Determination 2013/049

Regarding the refusal to issue a code compliance certificate for 7-year-old building work at 550 Whitecliffs Road, Coalgate

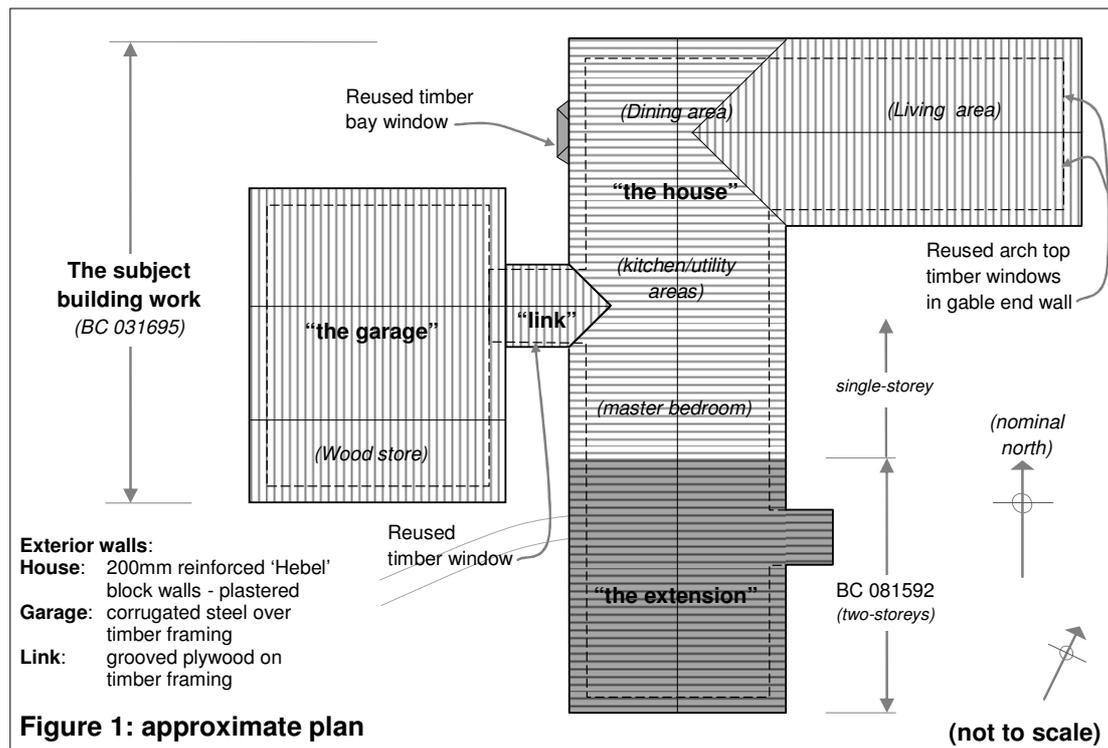
- 1.5.1 The completed building was constructed under two building consents as illustrated in Figure 1. The initial work was carried out under building consent No. BC 031695 (“the first consent”). A second consent (BC 081592) was subsequently issued; a code compliance certificate was issued for this consent on 8 February 2011. The determination is limited to the building work in the first consent.
